**FEASIBILITY ANALYSIS OF
RENOVATION AND EXPANSION OF SHENANDOAH COUNTY COURTHOUSE
AS PROPOSED BY CITIZENS FOR DOWNTOWN COURTS**

June 18, 2007

MOSELEYARCHITECTS
A PROFESSIONAL CORPORATION

Diagram A

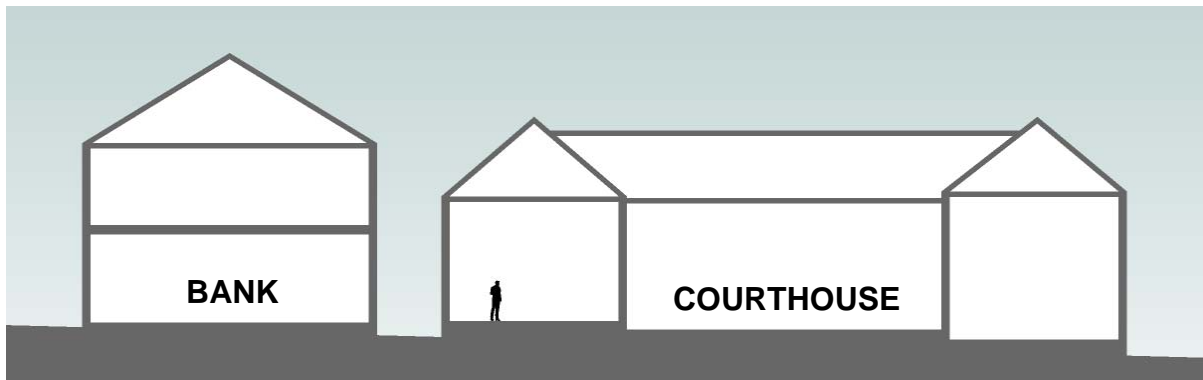
The primary architectural factors to be considered in evaluating the feasibility of the CDC proposal are the relative elevations of the various building floors and the availability of adequate headroom to provide for appropriate ceiling heights and above-ceiling building systems. Diagram A illustrates the relationship of the various floor and attic levels, and their relationship to Court Street, all as determined by Walsh Land Surveys, Incorporated.

The original Courthouse fronting on Main Street (at right in diagram) was constructed in the 1790's. The middle portion (current courtroom) was added in 1871, and the rear portion (current clerk's office) in 1880. As the diagram indicates, the Courthouse first floor actually consists of three different floor levels. Apparently this results from the fact that the Courthouse property slopes gently upward from Main Street toward the Bank, so each of the two additions to the original Courthouse has a correspondingly higher floor. The difference in elevation between adjacent floors is less than two feet in both cases.

The first floor of the Bank building is between two and three inches lower than the first floor of the adjacent 1880 courthouse wing. Since the two floors are at nearly the same level, connecting them together would be relatively simple assuming that the level of the adjacent Courthouse floor is not altered.

Diagram B

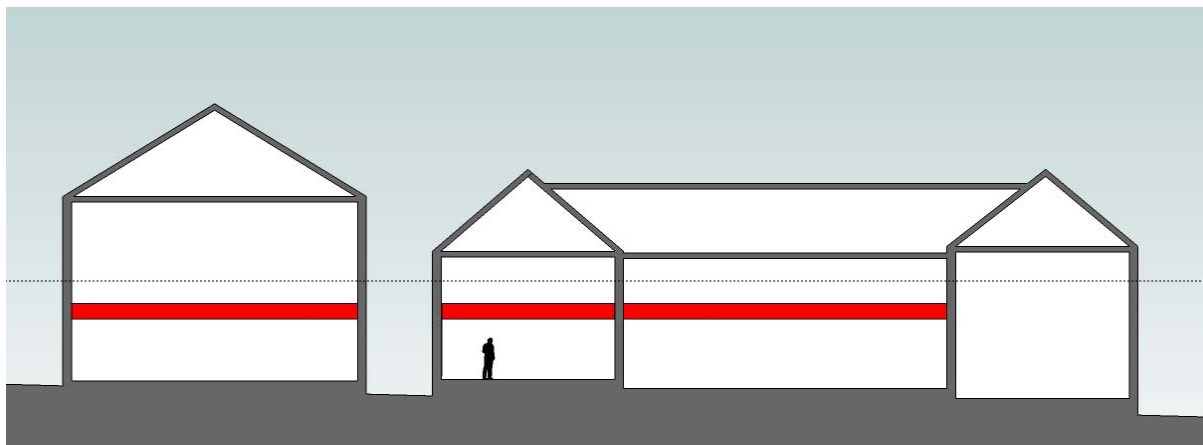
Diagram B illustrates the proposed construction of a new second floor in the Courthouse. Proposed new construction is indicated in red. The dashed line indicates the elevation of the existing second floor in the Bank. Height limitations in the Courthouse will prevent its new second floor from being constructed to align with the existing second floor of the Bank. CDC thus proposes removal of the existing second floor of the Bank and construction of a new one at a lower elevation. This new floor is also shown in red. The diagram does not indicate alterations to the roof structure of the Courthouse that would be necessary to achieve adequate headroom for the new second floor. That issue is addressed below.

CDC proposes to lower the existing second floor of the Bank building to align with the proposed new second floor of the Courthouse (see Diagram B). As with the Courthouse, it is not recommended that additional structural loading be applied to the original, existing bearing walls by pocketing new floor joists into those walls. The "insertion" of an independent structure like that proposed above for the Courthouse would therefore be required. This new steel framing would support only the new floor, as no modifications to the existing roof structure would be required. So as to avoid the need to temporarily brace the exterior walls during construction, the existing second floor should be demolished only after the new second floor framing has been secured to the exterior walls. The same care in construction of new footings would be required as described above for the Courthouse.

Diagram C

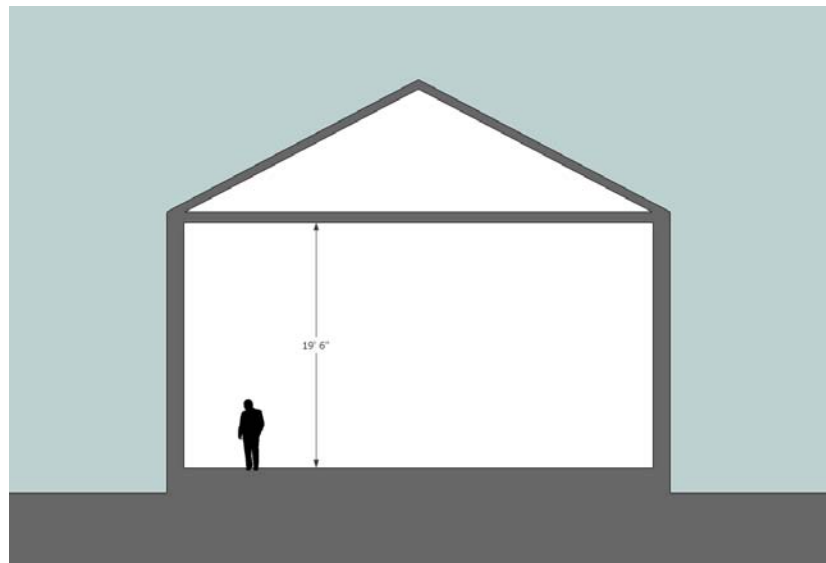
Diagram C shows a cross-section of the 1871 center portion of the existing Courthouse at the courtroom.

The height from the existing courtroom floor to the bottom of the lower tie beam of the roof truss is about 19'-6". (The ceiling height is actually lower, but the ceiling is suspended from the roof structure and can be removed with no impact on the structure.) Hal Craddock's letter of May 18, 2007, to Vince Poling proposes constructing the new second floor of the Courthouse at a height of eleven feet above the first floor of the rear wing of the building. This would place it about 12'-4"

above the first floor of the center portion of the building since the first floor in that part of the building is about 1'-4" lower than the first floor of the rear wing (see Diagram B).

Diagram D

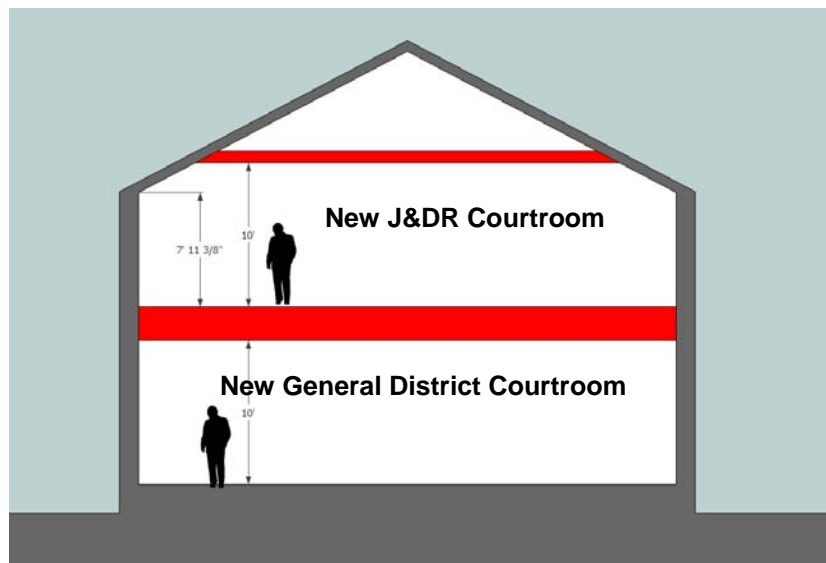
As Diagram D indicates, a ceiling height of ten feet can be achieved in the new second floor courtroom over part of the room, but the slope of the roof will reduce the height of the ceiling

to less than ten feet over about twenty percent of the room, and to less than eight feet at the exterior walls. Nevertheless, the symmetrical configuration of the sloped ceilings along the sides of the room may be compatible with the proposed courtroom use even though a minimum height of ten feet would not be maintained throughout the entire space.

Placing the new second floor at the proposed height above the existing courtroom floor while maintaining a minimum ceiling height of ten feet in the new first floor courtroom will provide for a space 2'-4" deep between the first and second floors. As in most buildings, this space between the floors would be occupied by structural framing and by building systems such as ductwork, light fixtures, piping, electrical conduit, and data cabling. Typically a depth greater than 2'-4" is required to adequately provide for these systems in a building such as a courthouse. A minimum requirement of three feet is a reasonable assumption in this case. Providing that amount of space would require that the floor be eight inches higher than proposed by CDC. The lower tie beams of the roof structure could probably be placed higher than shown in Diagram D in order to compensate, but the ceiling heights around the perimeter of the second floor J&DR courtroom would be further reduced and the overall area of the sloped ceiling within the room would be increased, adversely affecting the viability of the proposed design.
